Pre-Application Consultation Report:
Land Rear of 40 Victoria Road
Fleur De Lis

December 2023

Proposal: Full planning application for demolition of 40 Victoria Road, erection of 5 detached dwellings and formation of a new access.

01 SIDE ELEVATION - HOUSE TYPE 3
1:100

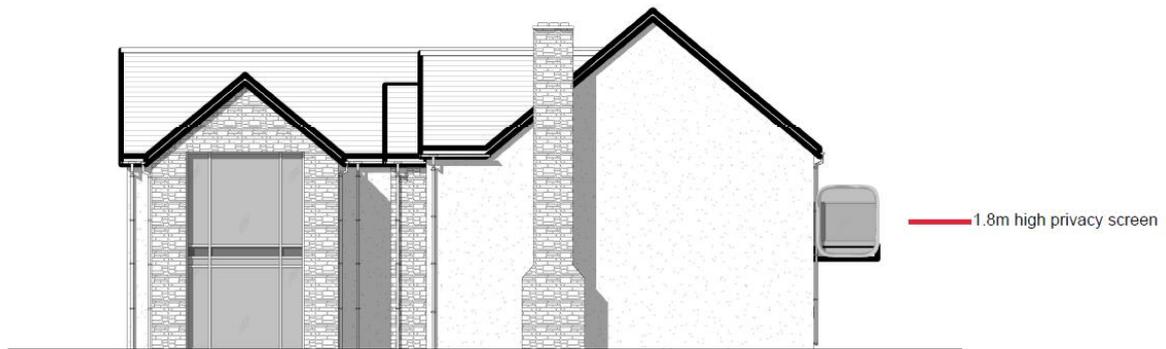
- 4.8. Of the 26 properties notified, 1 response was received on the 20th December; attached at Appendix 9. In summary, the objection is to potential overlooking of the rear of numbers 25, 26 & 27 Victoria Road from a first floor balcony on the rear elevation of house type 3 (plot 1).

- 5.10. The balcony in question can be seen on plans N345-A1.10 - House Type 3 - Front and Rear Elevation Rev (A) and N345-A1.11 - House Type 3 - Side Elevation Rev (A). It is situated at the rear of a small bedroom and projects out from the rear elevation by 1.5m. As can be see from the plans, the main view from the rear elevation will be north-northeast, along the valley, rather than towards Victoria Road.

- 5.11. However, it is acknowledge that if someone stood on the balcony and turned 90 degrees they could face towards the rear of the properties on Victoria Road. This has been taken into account by ensuring that the proposed dwellings are sited sufficiently far away from the rear of neighbouring properties to avoid any potential overlooking.

- 5.14. However, the applicants have been very careful to try and ensure that the proposed layout does not impact on their neighbours and are more than happy to include a '1.8m high privacy screen' on the end of the balcony to reassure the local residents and ensure there are no views from it towards Victoria Road. This privacy screen has been added to the side elevation

drawing N345-A1.11 - House Type 3 - Side Elevation Rev (A), an extract of which is shown below:
